Response to Referee Comment 2 on “*Rayleigh wind retrieval for the ALADIN airborne demonstrator of the Aeolus mission using simulated response calibration*”

We appreciate the referee’s insightful and valuable comments on our manuscript AMT-2019-274. We thank the referee explicitly for careful proofreading, which significantly improve the clarity of the text and the readability for a broader audience. According to the suggestions and questions, the point-by-point response is attached in this file.

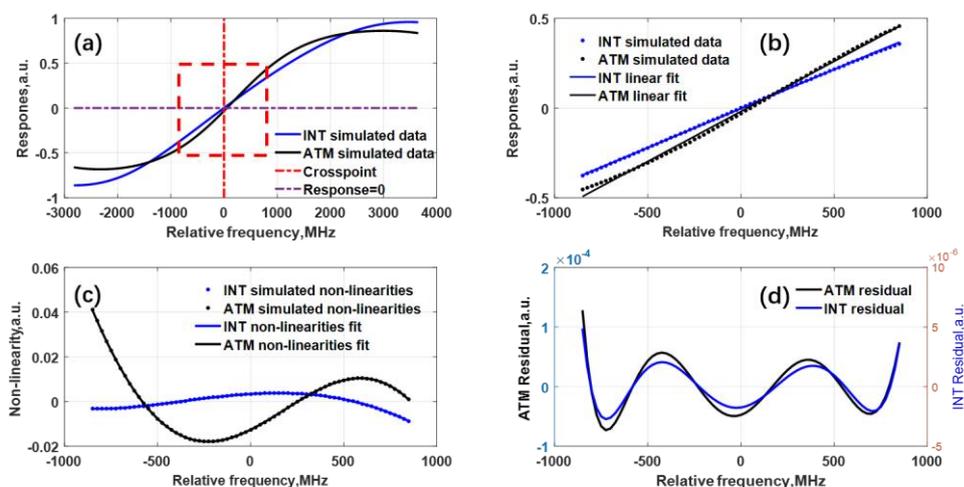
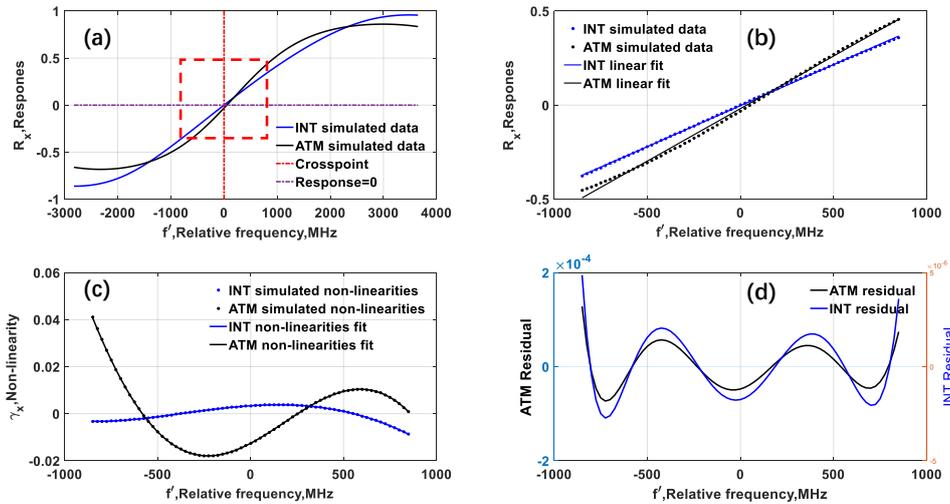
Line 9: The text says that the red-square marks ± 850 MHz, but the figure looks like its closer to 1 GHz. Please rectify one or the other to match.

Figure 3: Again, refer to the variable f_c when discussing the cross point frequency.

R: Figure 3 has been updated in the revised manuscript.

R: revised.

Figure 4: Flowchart of LOS velocity retrieval and comparison between A2D SRRC and MRRC.

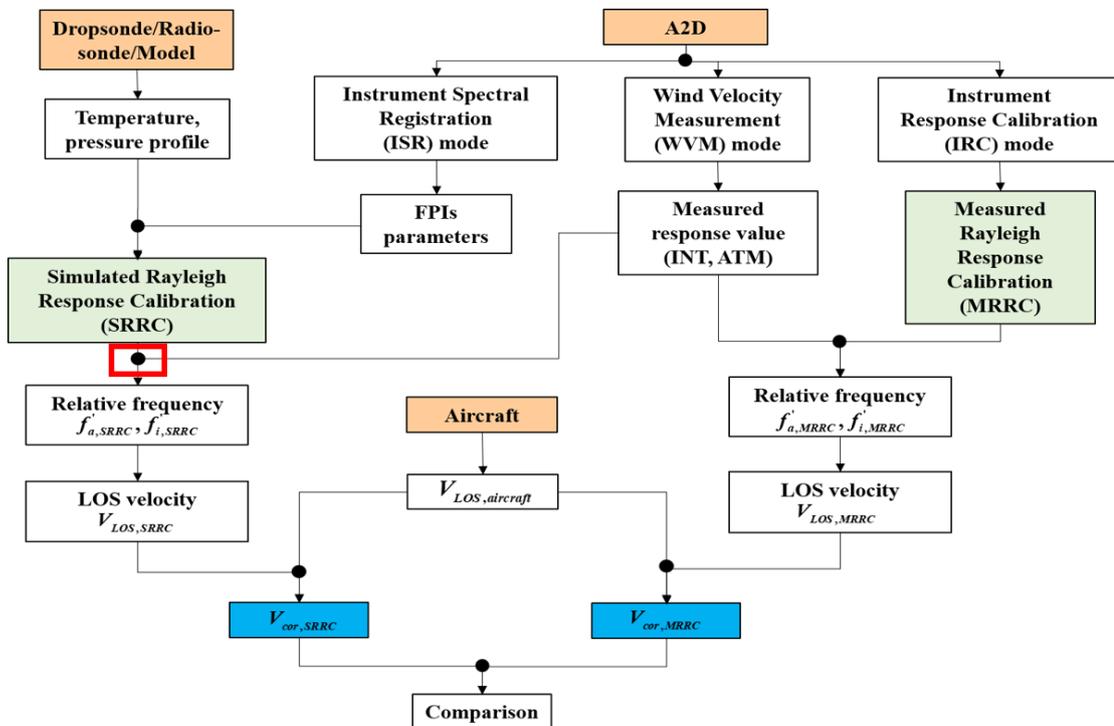
- Page 10 Line 13-14: The authors state that the, “measured response values obtained from A2D wind velocity measurement mode are brought into the fitted SRRC...” What does “brought into” mean here? Is this a mapping? What is the process for doing this?

R: revised. Change “brought into...” to “combined with...”, the specific process for doing this is marked with red-line square in the figure below. Please see [Sect 5 Page 12 Line 15](#).

Figure 8: The effect of the centre frequency offset Δf_0 of filter A and B for atmospheric path on atmospheric response (a) β_{ATM} (b) α_{ATM} and (c) corresponding cost function $F(\Delta f_0)$.

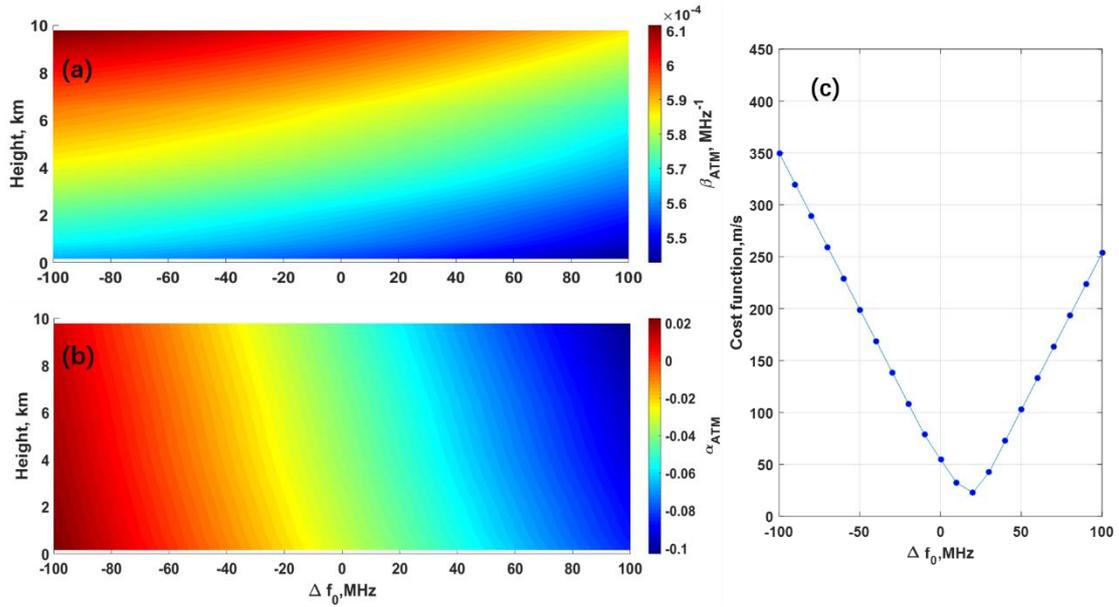
The authors seem to change terminology back and forth throughout this section (and the corresponding figures) which makes reading the section slightly more challenging. Specifically, on page 8 the terms defined in Equations 8 and 9 are referred to as beta= sensitivity and alpha=intercept, but in Figures 7 and 9 only the terms sensitivity and intercept are used. Perhaps adding the variable names beta_ATM and delta-alpha_ATM to the captions for figure7 and 9 would help. Likewise add the descriptive terms to the caption for figure 8.

Lines 15-20: The text refers to the plots in Figure 8 and talks about range gates, but the figure shows altitude bins. Which terminology should be used?

R: revised.

R: revised. Replace “range gate” with “altitude bin” in the revised manuscript. Please see [Sect 5.2 Page 14 line 18-20](#): “The responses of internal reference (red) and the 8th atmospheric altitude bin (blue dashed line, the corresponding height is around 5.7 km) from measurement and corresponding SRRCs are listed in Table 4 and shown in Fig. 6.”

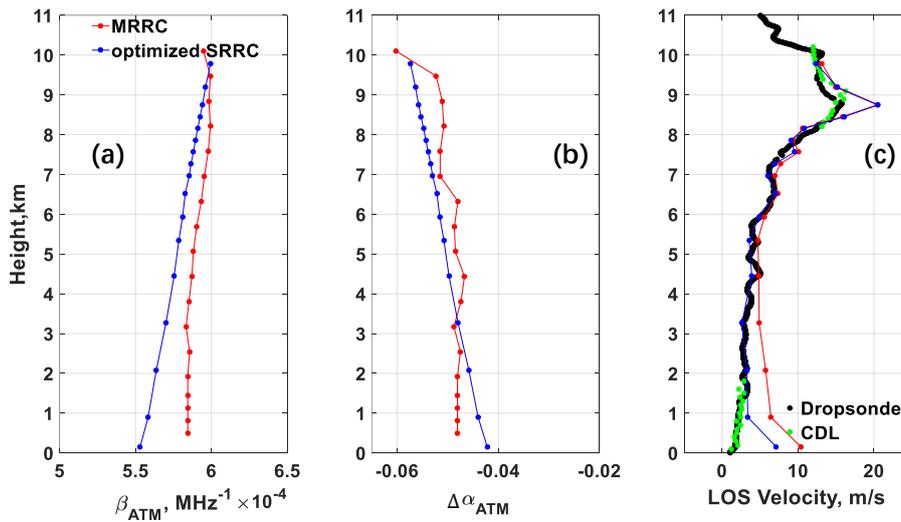
Figure 9: clarify that (c) represents the retrieved LOS velocity

R: revised.

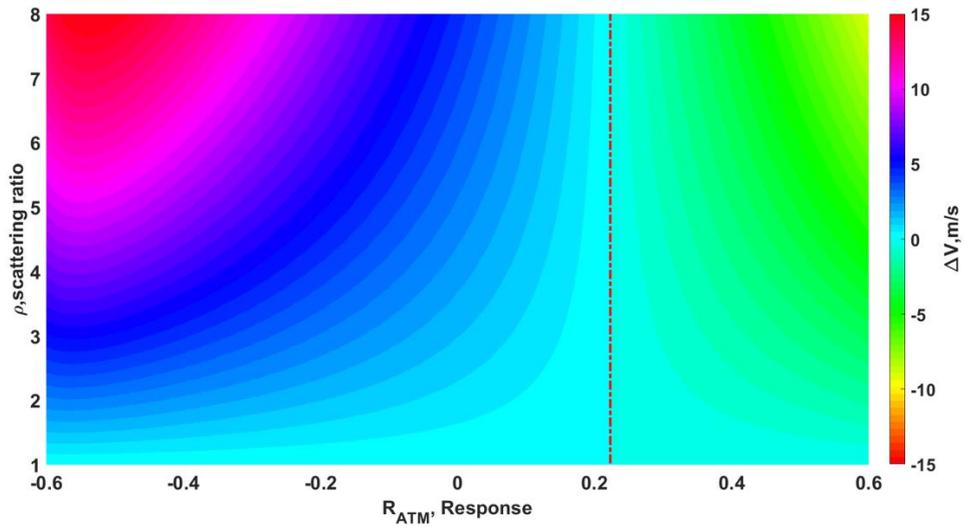
7. Page 8 Line 1: Here the authors could clarify for the readers not familiar with double edge approach why the biases are worse when Mie signal is significant but not good enough to measure winds using the Mie channel. Can this be shown somehow in Figure 2?

Figure2: Please also use the variable name (e.g. “Rx”) with “Response” (in the caption and the axis labels)

R: revised.

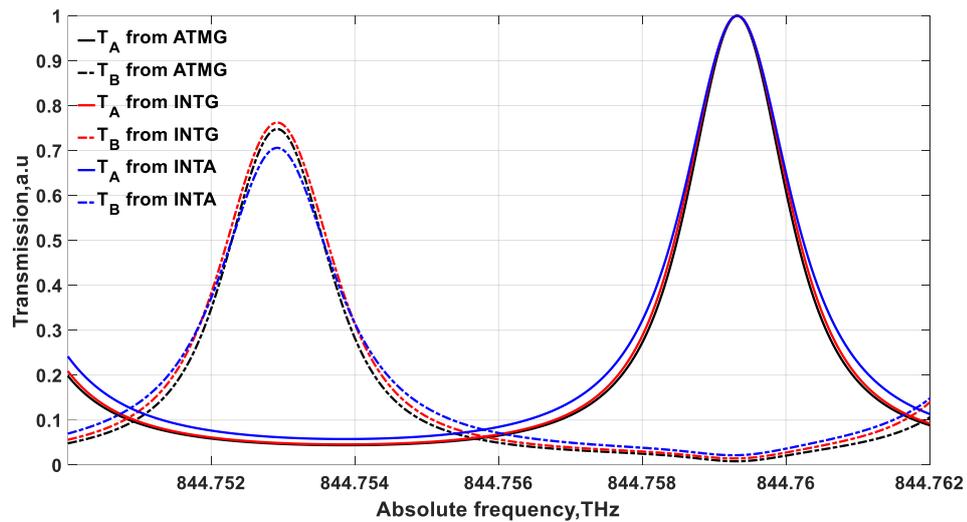
Figure 5: Should the blue dashed curve be labeled “TB from INTA” (vs. TA) ?

R: revised.

Figure 12: Comparison of profiles for LOS velocity (a) between A2D SRRC and MRRC (b) SRRC and dropsonde (c) MRRC and dropsonde.

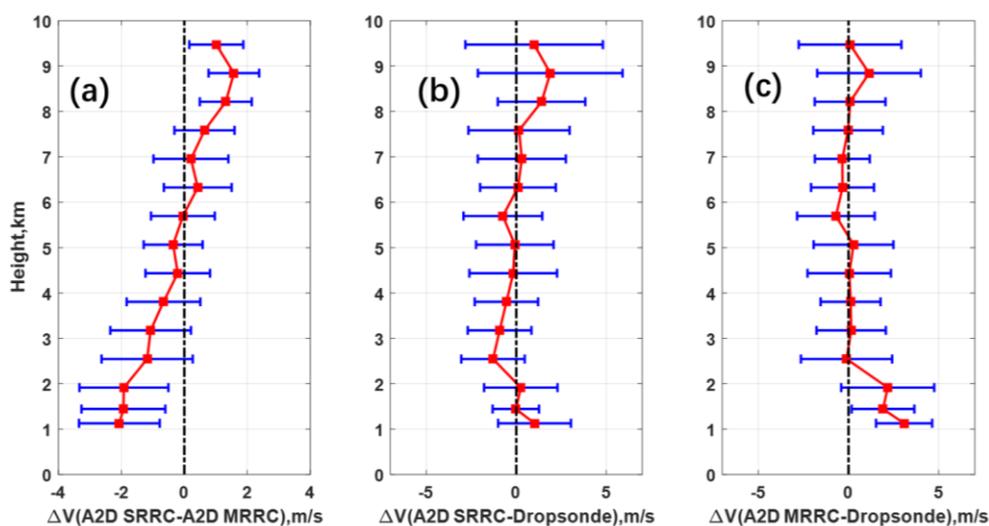
Can the authors provide error bars on the LOS velocity retrievals? Even CDL systems have errors.

R: revised. The error bars of LOS velocity derived from MRRC and SRRC can be seen in Figure 12 (b), (c), respectively. The CDL provides high performance with accuracy of <0.3 m/s and precision of <1 m/s, respectively (Chouza, F. et al., 2016), thus we prefer to plot no error bars to the CDL measurements. Please see [Sect 6 Page 18 Line 9-11](#).
